Access Compliance Report

Public Rights-of-Way

(Curb Ramps)

Intersection ID: 30478	Main Street: CREEK_TURN_DR	Cross Street: EBULLIENT_ST	Location: SW
ADA ID: 4F31F55DF42A	Ramp Type: PerpDiag	Initial Pass/Fail: Fail	Overall Compliance: No
		Severity Score: 47.5

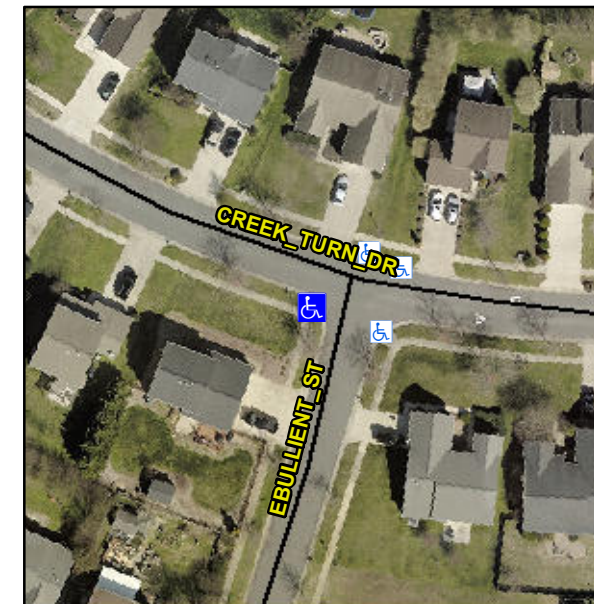
R304.5.1, R304.2.2

Compliance	Description	Data	Compliance	Description	Data
N/A	Ramp Length (in)	86.0	No	Ramp Slope (%)	8.6
No	Ramp Width (in)	30.0	Yes	Ramp XSlope (%)	1.9
N/A	Flare Type LT	N/A	N/A	Flare Type RT	N/A
N/A	Flare Slope LT (%)	N/A	N/A	Flare Slope RT (%)	N/A
N/A	Flare Traversable LT?	N/A	N/A	Flare Traversable RT?	N/A
N/A	Landing Length (in)	N/A	N/A	DWS Provided?	N/A
N/A	Landing Width (in)	N/A	N/A	DWS Contrast?	N/A
N/A	Landing Slope (%)	N/A	N/A	DWS Length (in)	N/A
N/A	Landing X Slope (%)	N/A	N/A	DWS Full Width?	N/A
N/A	Landing Curb? (Y/N)	N/A	N/A	DWS Offset (in)	N/A
N/A	Shared Landing?	N/A			
N/A	Gutter Ponding?	N/A	N/A	Gutter Slope (%)	N/A
N/A	Gutter Lip Ht (in)	N/A	N/A	Gutter X Slope (%)	N/A
N/A	Painted X Walk1?	No	N/A	Painted X Walk2?	No
	X Walk 1 Direction	To SE		X Walk 2 Direction	To NE
N/A	X Walk 1 Width (in)	N/A	N/A	X Walk 2 Width (in)	N/A
	X Walk 1 Slope (%)	1.7		X Walk 2 Slope (%)	3.0
	X Walk 1 X Slope (%)	1.8		X Walk 2 X Slope (%)	1.3

Remove & Replace Curb Ramp With Two New Directional Ramps or Equivalent.
